PSE IRP Feedback Report
Webinar 6: Portfolio Sensitivities
August 11, 2020

The following stakeholder input was gathered through the online Feedback Form, from August 4 through August 18, 2020. PSE's response to the feedback can be found in the far-right column. To understand how PSE incorporated this feedback into the 2021 IRP, read the Consultation Update, which will be released on September 1, 2020.

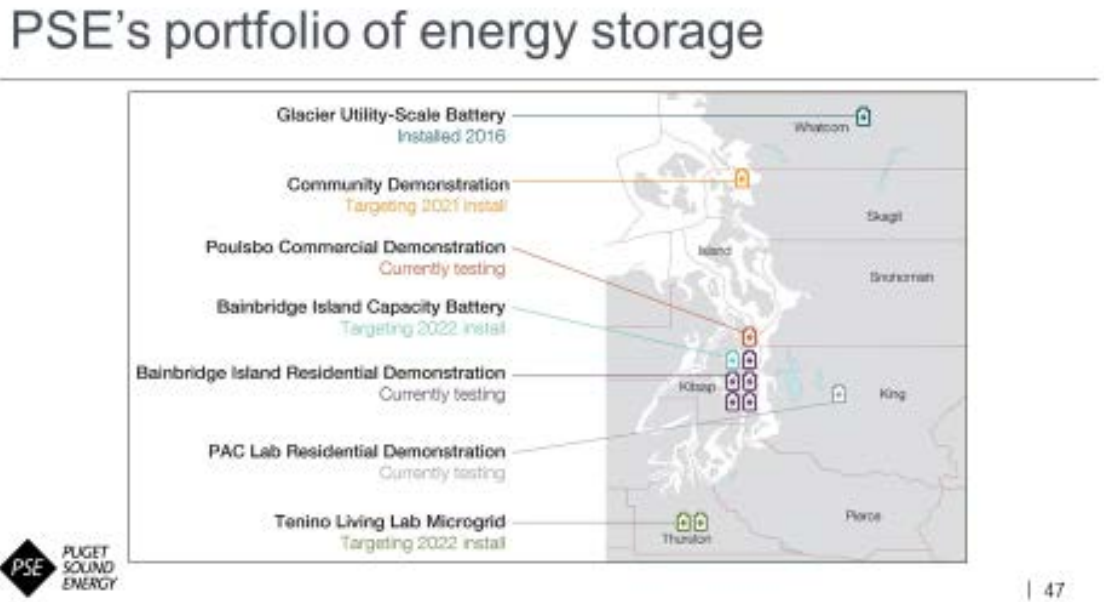
Feedback Form Date	Stakeholder	Comment	PSE Response
			 <p>The map displays PSE's energy storage portfolio across Washington state, with projects marked by colored icons and labels:</p> <ul style="list-style-type: none"> Glacier Utility-Scale Battery: Installed 2016 (Whitcomb) Community Demonstration: Targeting 2021 install (Skagit) Poulsbo Commercial Demonstration: Currently testing (Island) Bainbridge Island Capacity Battery: Targeting 2022 install (Island) Bainbridge Island Residential Demonstration: Currently testing (Island) PAC Lab Residential Demonstration: Currently testing (King) Tenino Living Lab Microgrid: Targeting 2022 install (Thurston) <p>Other counties shown include Whatcom, Skagit, Snohomish, King, and Pierce. The PSE Puget Sound Energy logo is in the bottom left, and the page number '47' is in the bottom right.</p>
8/18/2020	Kyle Frankiewicz, WUTC Staff	Slide 54: How soon will these forecasting and hosting capacity capabilities be available? Will this granularity prompt a revisit of the system-wide T&D deferral estimates?	PSE will be addressing these questions in the consultation update on September 1, 2020.
